REQUEST FOR INFORMATION	DATE: May 03, 2016	NO.: RFI-060
--------------------------------	---------------------------	---------------------

Project Name: Webster University Interdisciplinary Science Building Project No.: 15051

Subject: Vertical Bracing Connection Design Joint Forces

Floor Type: Level 02

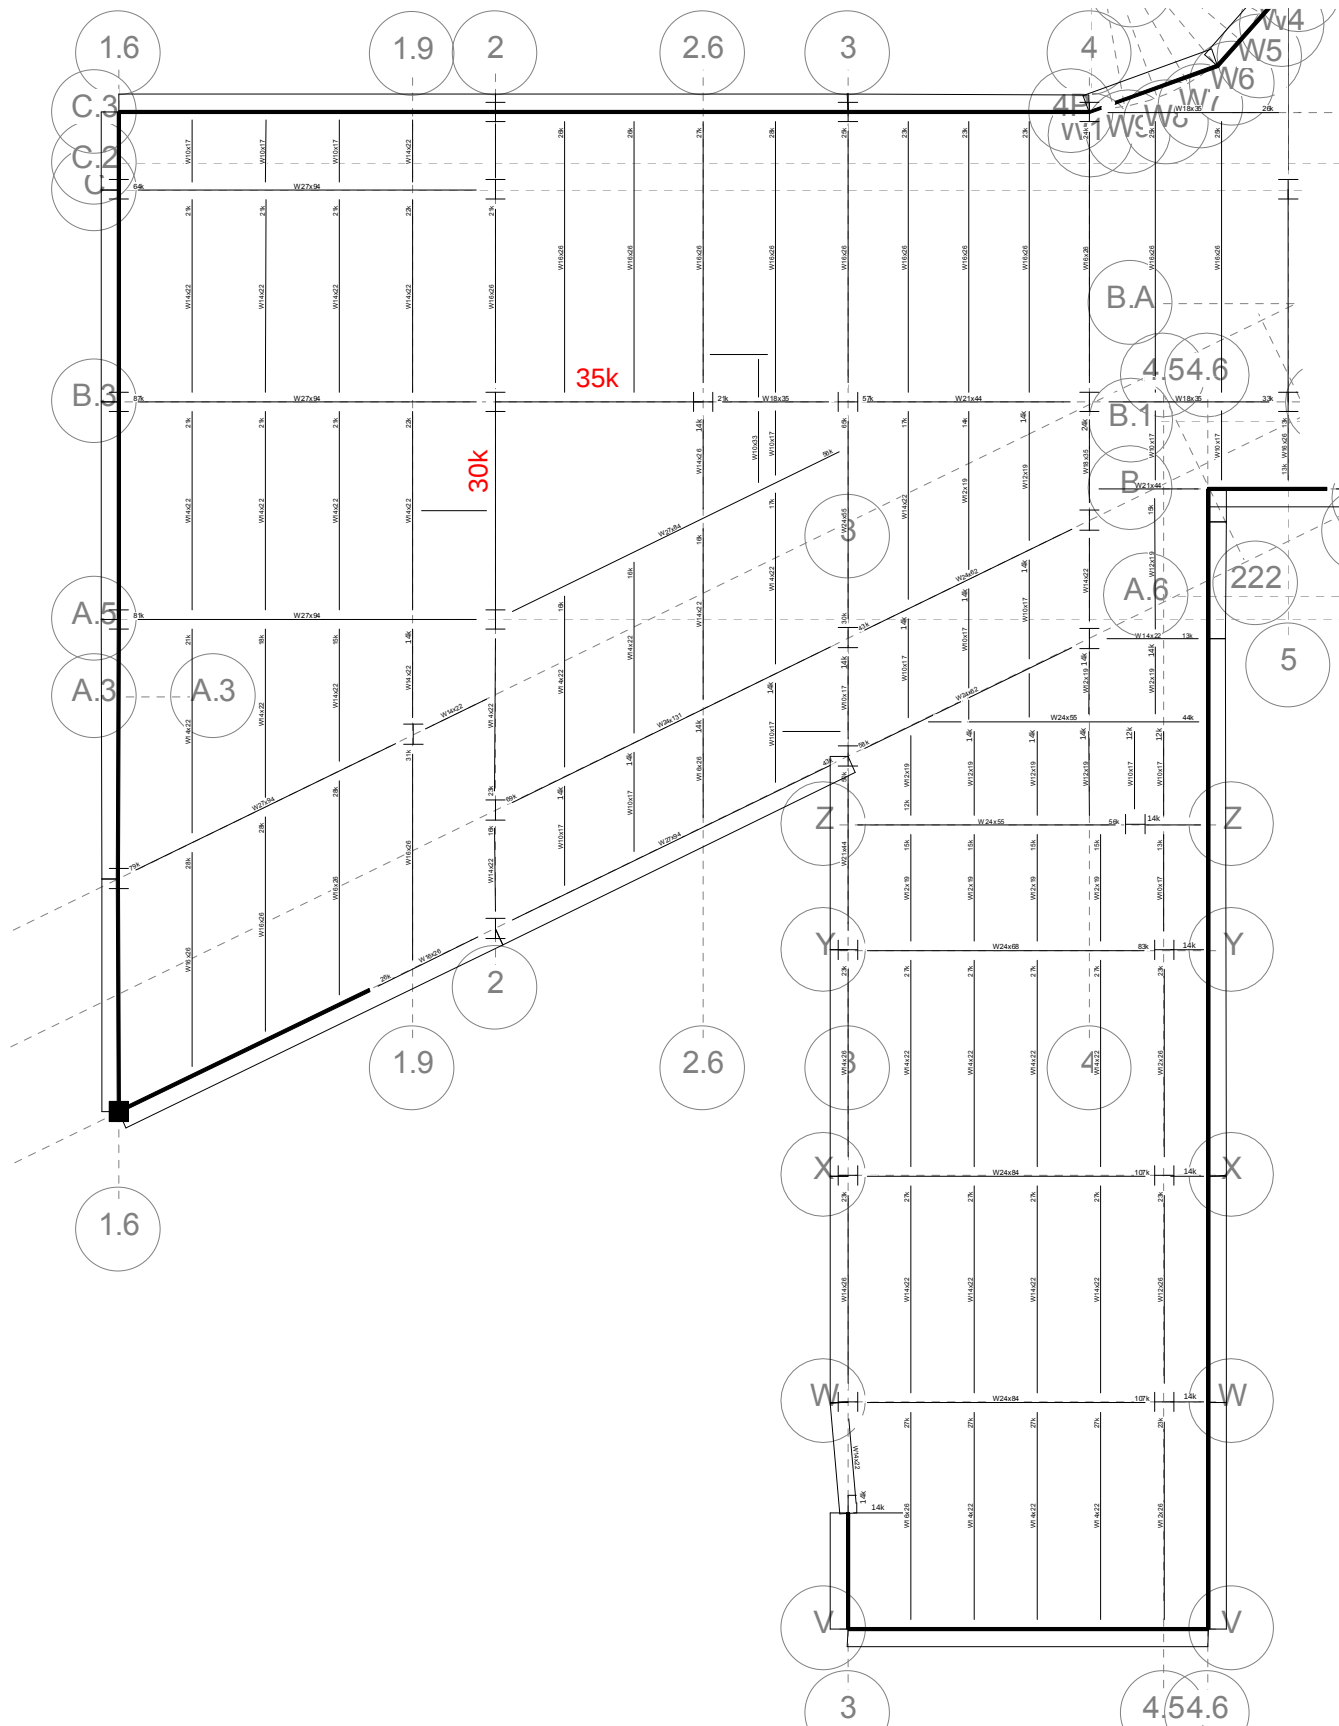
Please advise the shear connection for each beam at braced frame. They are missing from floor reaction files we received.

Attached are the composite beam reactions requested. These are the same documents sent on 5/5/2016 to AIW.
